Technical Note

Project: Land North of the Viaduct, Ledbury

Subject: Response to HC Comments

Client:	Bloor Homes Western	Version:	4
Project No:	3468	Author:	JW
Date:	03/05/2019	Approved:	ME

Figure 2-1: Walking Routes between Development and Trading Estate

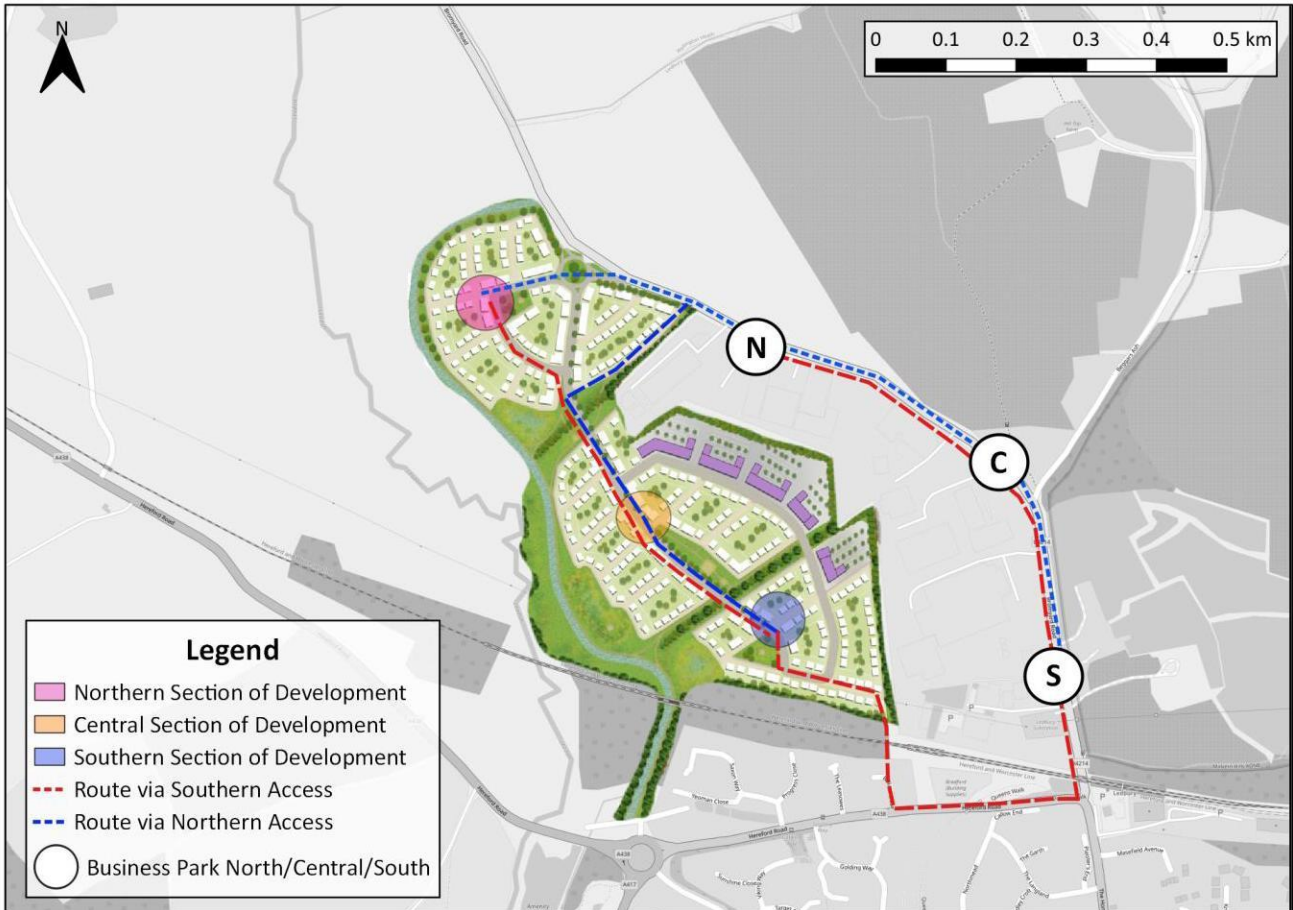
- 1 Additional analysis of walking and cycling distances from the site to the Bromyard Road Trading Estate;
 - 2 Additional analysis of pedestrian demand at the Hereford Road / Bromyard Road / The Homend junction and its effect on the capacity of the proposed signalisation scheme;

- 2.1.2 Table 2-1 presents walking distances between each residential and trading estate sector, via the Ballard Close access and via Bromyard Road (from the proposed emergency vehicle and pedestrian access). These routes are presented within Figure 2-1.

2.1.3 In considering the above analysis and accessibility for future residents of the proposed development who may plan to walk to work within the Trading Estate:

- Those residents who live in the northern part of the residential development would need to walk 450m further to access the southern part of the trading estate, compared to the shorter route along Bromyard Road.
- The central part of the trading estate is inaccessible on foot in the existing and proposed situations, due to the lack of footway on Bromyard Road.
- For all other residents, the proposed infrastructure provision would allow safe access to the trading estate via the most direct potential route.

2.1.5 As previously described, there is no scope to provide a continuous footway along Bromyard Road within the adopted highway boundary. However, the following measures are proposed to maximise accessibility by sustainable modes:

- Provision of a footway on Bromyard Road from the proposed emergency access to serve the northern part of the Trading Estate;
- Provision of connections up to the development boundary with the Trading Estate to allow potential access to be made in future.
